‘Re:	FCC ID N7NAC750
Applicant:	Sierra Wireless Inc.
Correspondence Reference Number:	22318
731 Confirmation Number:	EA753377

SWEEP TABLE: "FCC 24 Spur 30M-1G"
Short Description: FCC 24 30MHz-1GHz

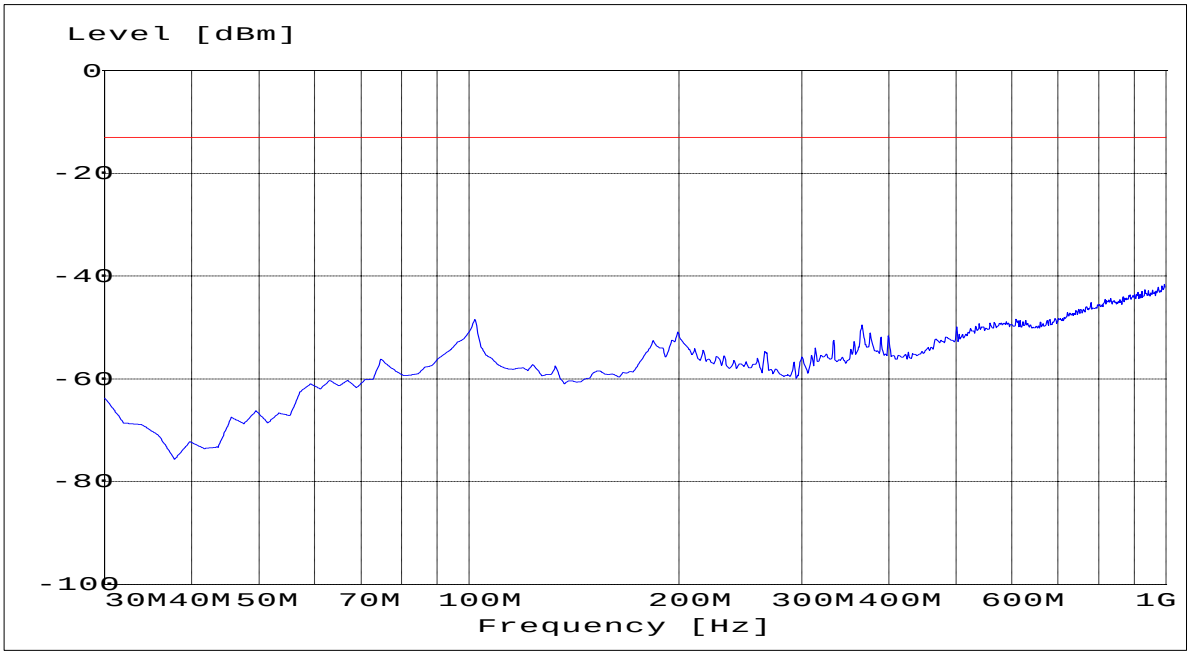
B) Regarding your answer to question 2 and the above reference phone call, it was stated that a sweep time of 5 ms was used for the 30-1000 MHZ plots on pages 14-27 of the test report. Please provide new data with at least 2 second sweep times while using a peak hold mode. Please perform this test with the rotating table moving at no more than 10 degrees in two seconds.’

Response to item B):
The plot below shows the results of testing with the settings and test method described in item B). These settings and test method produced identical results for the high, middle and low channels in either TX or idle mode. Only one result graph is included it shows the max. hold peak values for all the channels.
The model of host laptop used during this testing is different than that used for the previous testing. Any difference in the results is due to this difference in host laptop PC used for testing.
